MILITARY SPECIFICATION

MODULES, STANDARD ELECTRONIC

MEMORY, RANDOM ACCESS, KEY CODE ZJT

This amendment forms a part of Military Specification MIL-M-28787/303A(EC), dated 21 October 1982, and is approved for use by the Naval Electronic Systems Command, Department of the Navy, and is available for use by all Departments and Agencies of the Department of Defense.

FIGURE 22. Dynamic test circuit for table XVI.

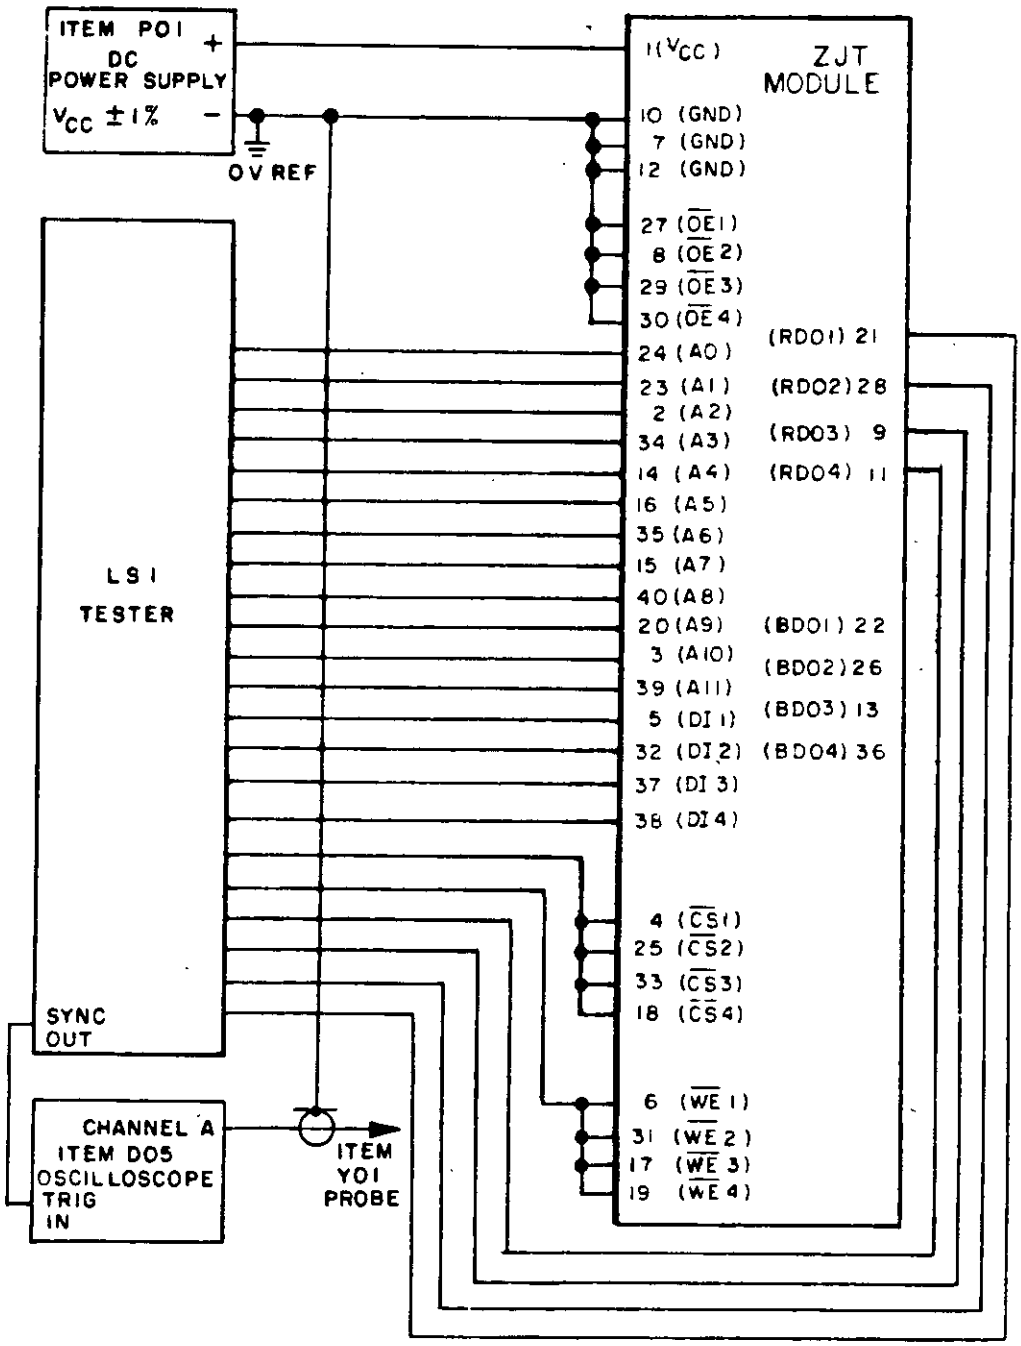
FIGURE 22: Delete and substitute new figure 22 as printed on pages 3 and 4 of this amendment.

NOTES:
1. V_{CC} = 4.5 V ±1% for test conditions R1, R3, R5, R7, R9, R11, R13, and R15.
2. V_{CC} = 5.5 V ±1% for test conditions R2, R4, R6, R8, R10, R12, R14, and R16
3. Load output pins 9, 11, 21, and 28 with load as specified on figure 14 wit
   C_L = 50 pF for test conditions R1-R8.
4. Load output pins 9, 11, 21, and 28 with load as specified on figure 14 wit
   C_L = 150 pF for test conditions R9-R16.
